# Errata Sheet

<b>Product Family:</b>	DL205 / DL305	<b>Date:</b>	September 2018
<b>Manual Number</b>	D2-DCM		
<b>Revision and Date</b>	2nd Edition; February 2003

### Point-to-Point RS422 D2-DCM as Master

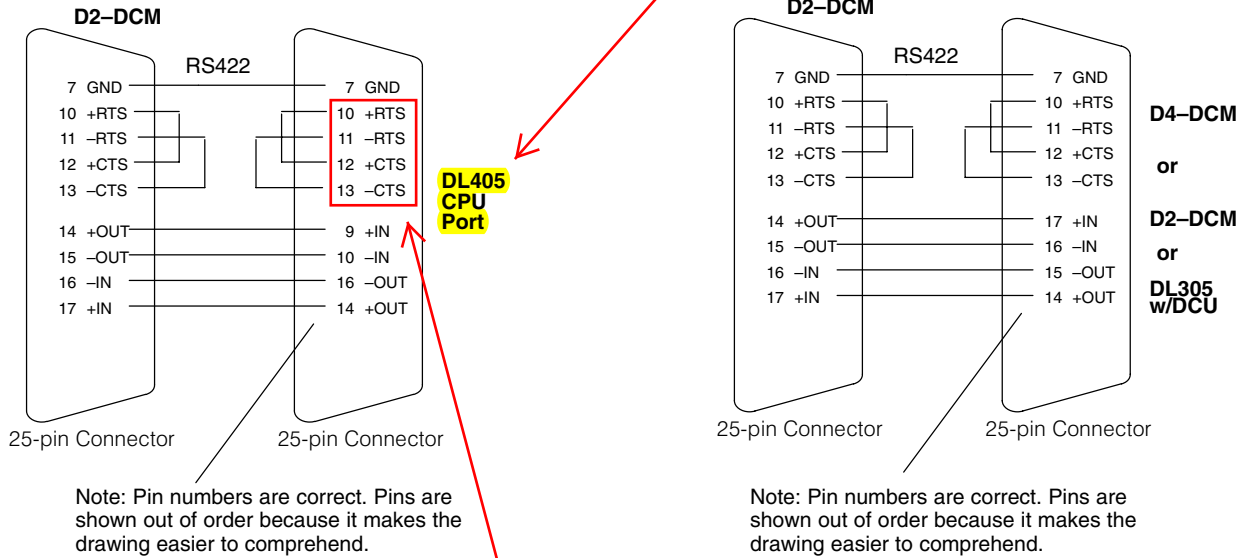
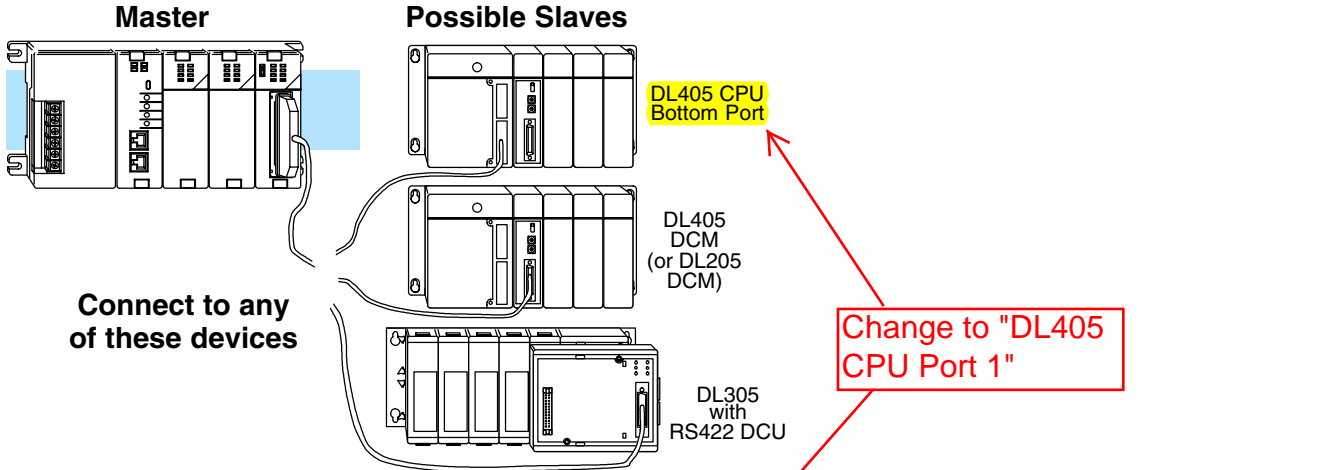
In the top set of drawings, change the callout that says “DL405 CPU Bottom Port” to DL405 Port 1”

Page A-4. Point-to-Point RS422 D2–DCM as Master

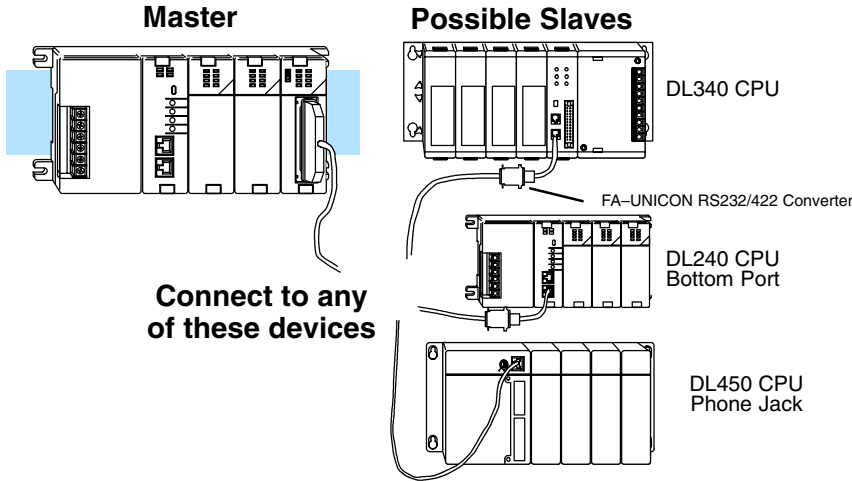
In the lower left drawing there are some pin number errors for the DL405 port 1 25-pin connector. The correct pin numbers are:

19 +RTS (not 10 as shown)

18 -RTS (not 11 as shown)

11 +CTS (not 12 as shown)

23 -CTS (not 13 as shown)

These pin numbers are incorrect. They should be:

- 19 +RTS
- 18 -RTS
- 11 +CTS
- 23 -CTS

**Multidrop  
RS422  
D2-DCM as Master**

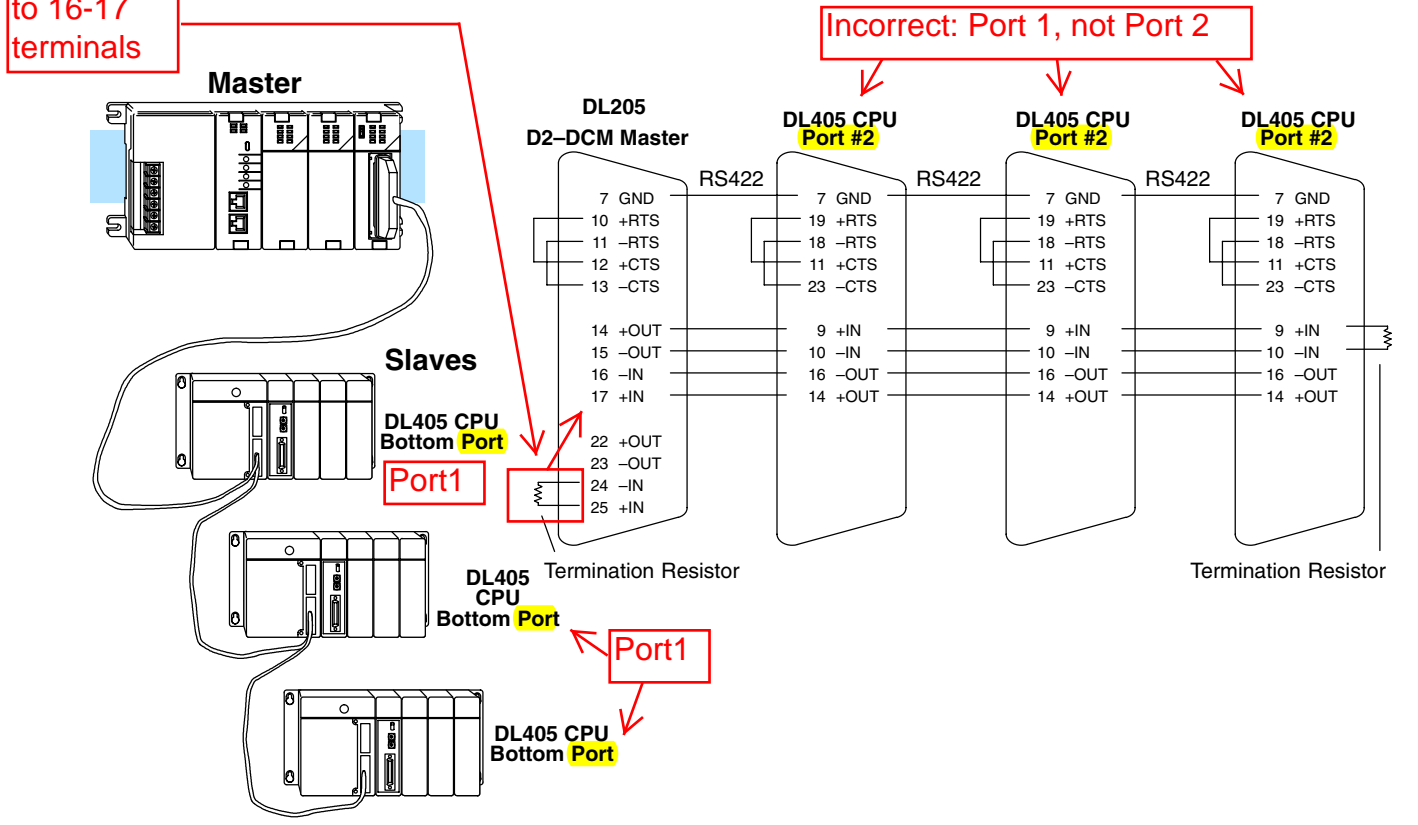
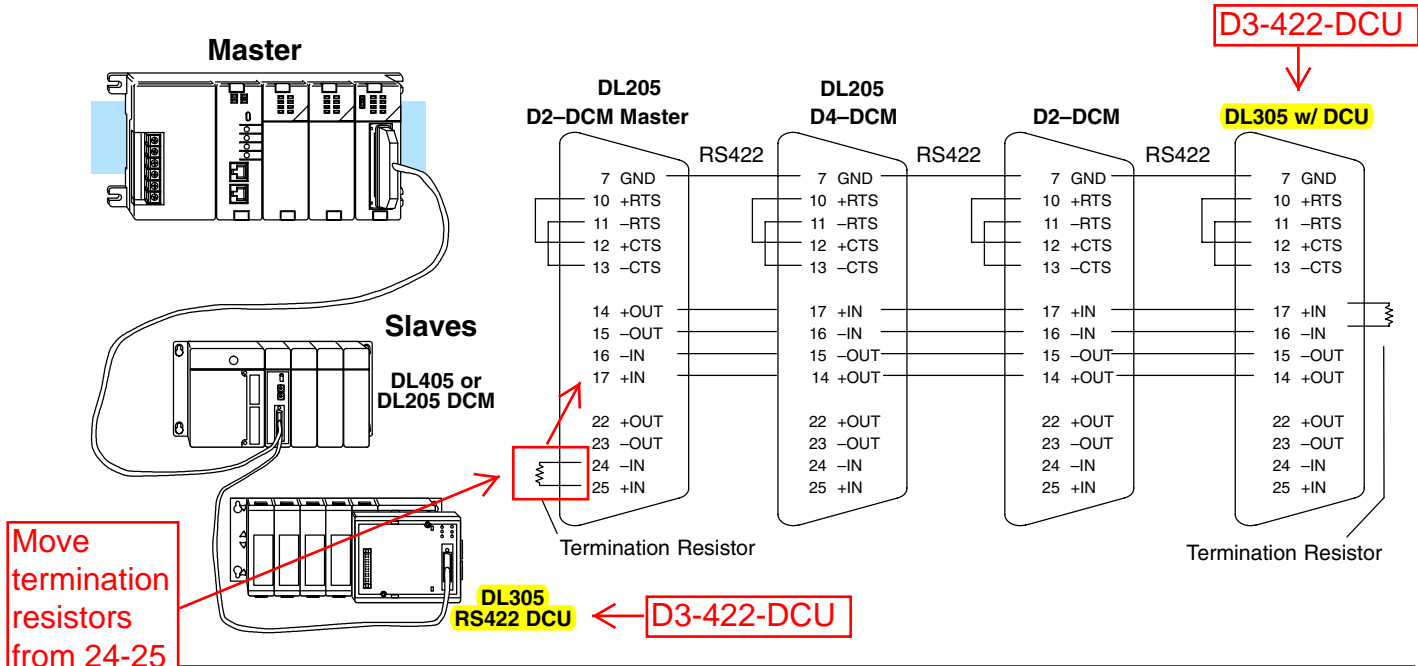
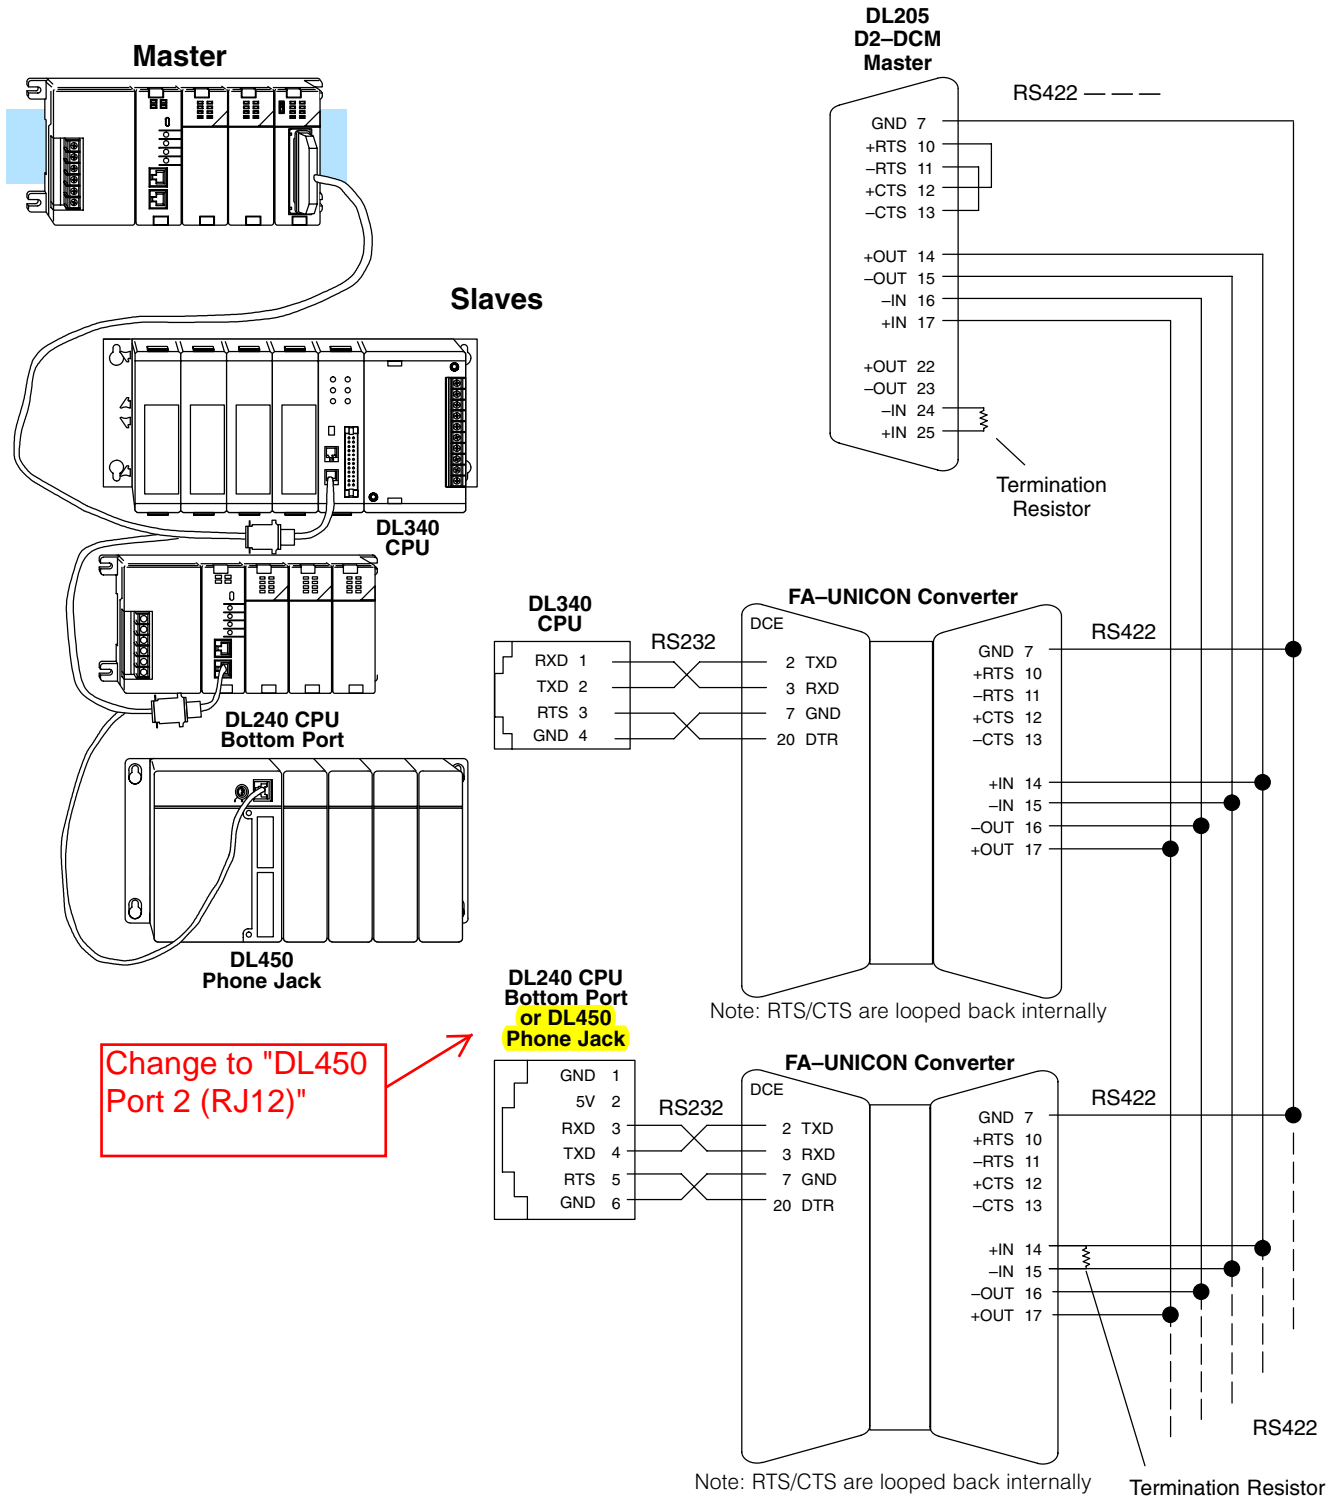
Page A-7. Revisions were made to both drawings:

See Errata Sheet at the beginning of this file.  
Both wiring diagrams below were revised.
